October 2022
INT FL951
NHTSA #22V-654
Transport Canada #2022-483
INTERIM RECALL

Subject: Western Star Grill Bezel Covers

Models Affected: Specific model years 2020-2023 Western Star 47X and 49X vehicles manufactured March 18, 2019, through August 26, 2022, and equipped with Inner & Outer Bezels on the grill.

Fig. 1, Masking Tape Locations

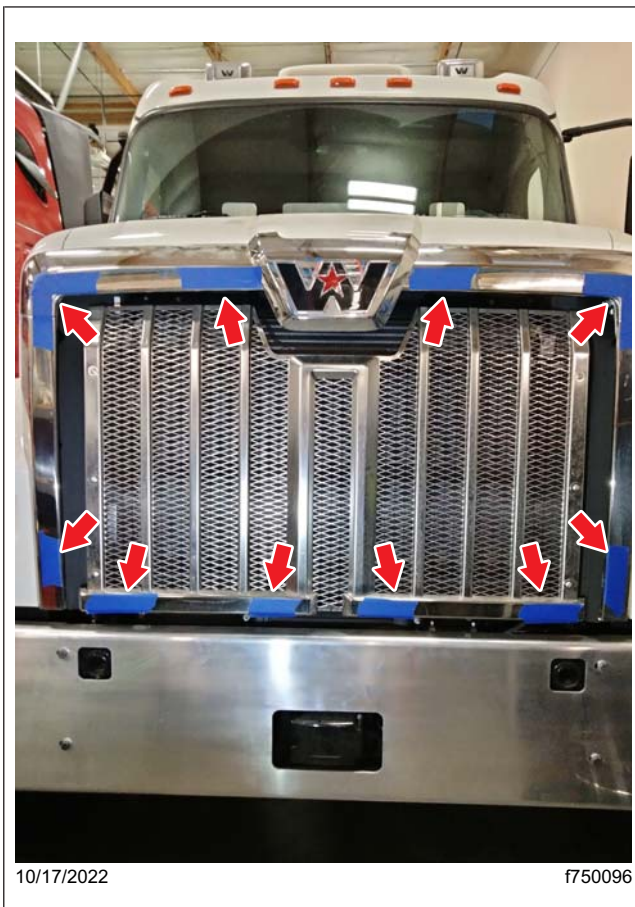
5. Cover the areas that need to be drilled, using masking tape. See **Fig. 1**.

Fig. 2, Hood Handle Removal

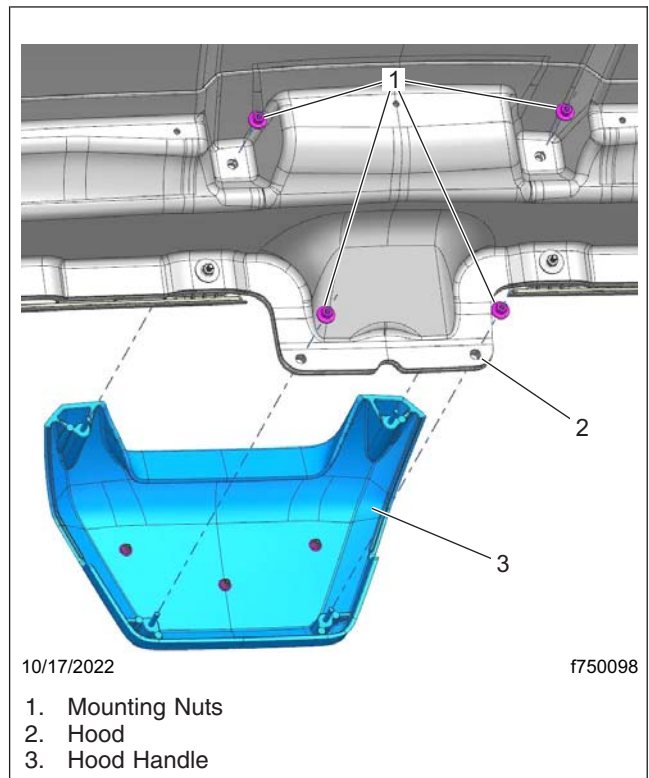
6. Remove the four mounting nuts that attach the hood handle to the hood. See **Fig. 2**.

Fig. 3, Drilling Location Measurements (left-hand side bezels shown)

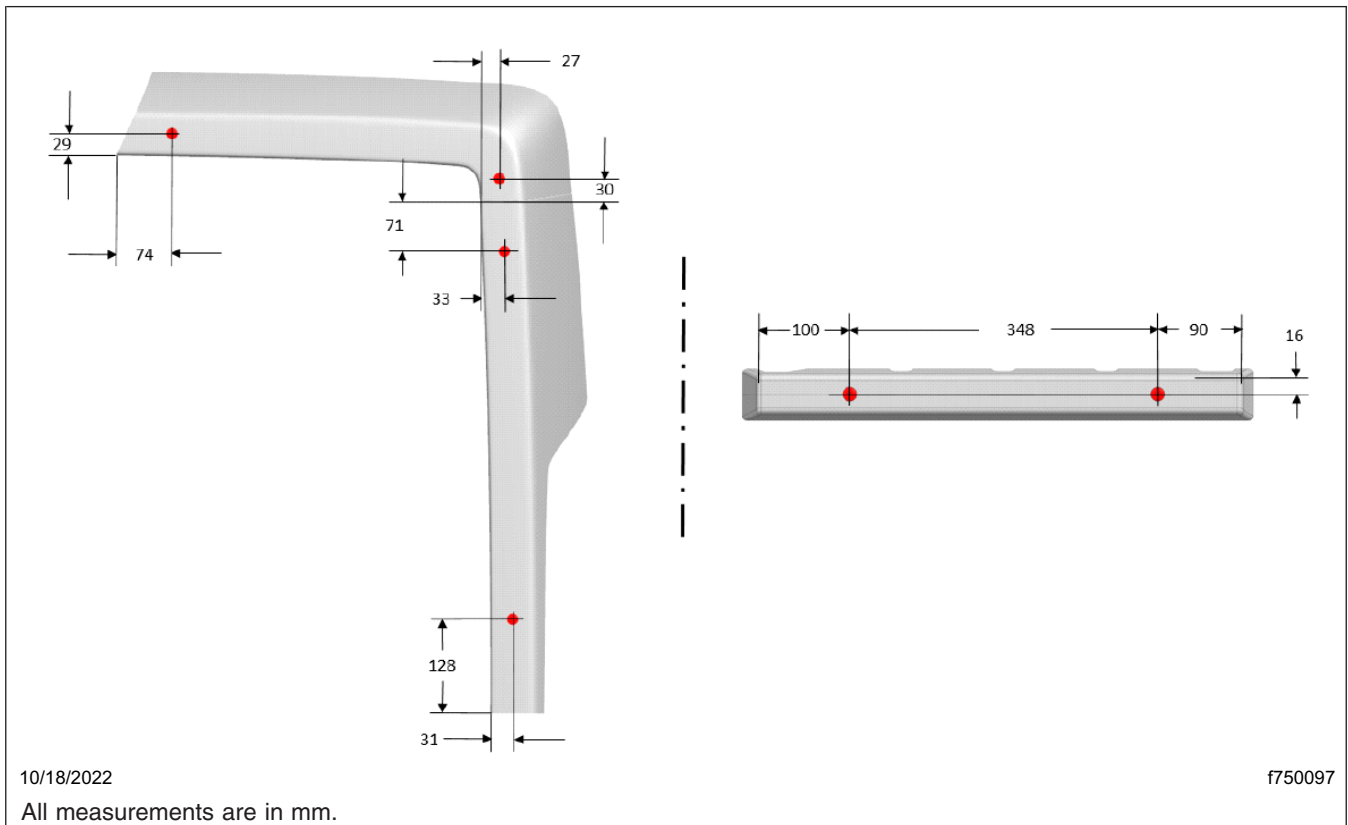
The upper and the side bezels curve together at the upper corners. Use a straight edge to precisely mark the drilling locations.

8. Mark all the drilling locations using the measurements provided in [Fig. 3](#).

9. Center punch the rivet locations, then use a 9/64-inch drill bit to drill 12 holes in the hood bezels.
10. Deburr the holes drilled in the hood bezels.

Fig. 4, Rivet Locations

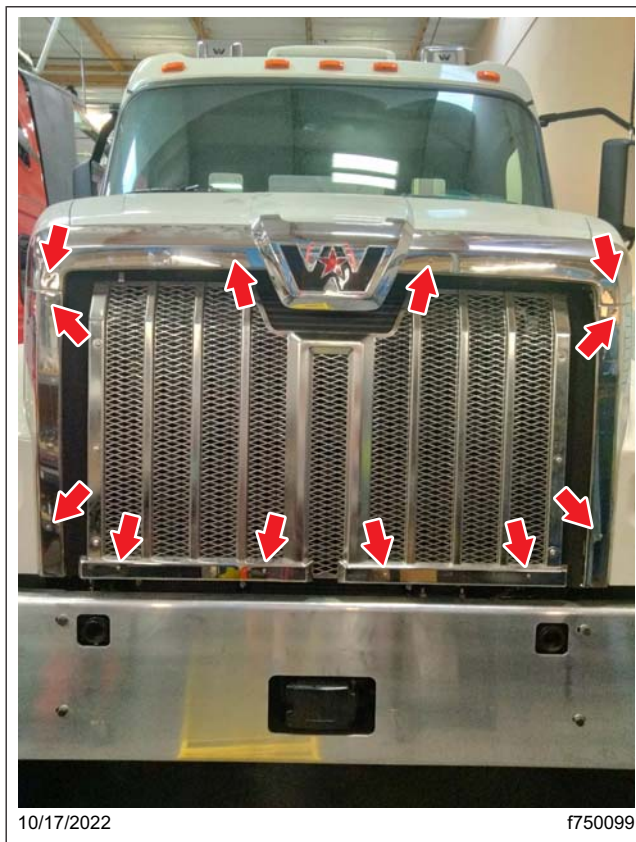
11. Install the rivets into each drilled hole. **Figure 4** shows the rivets installed on the hood bezels.
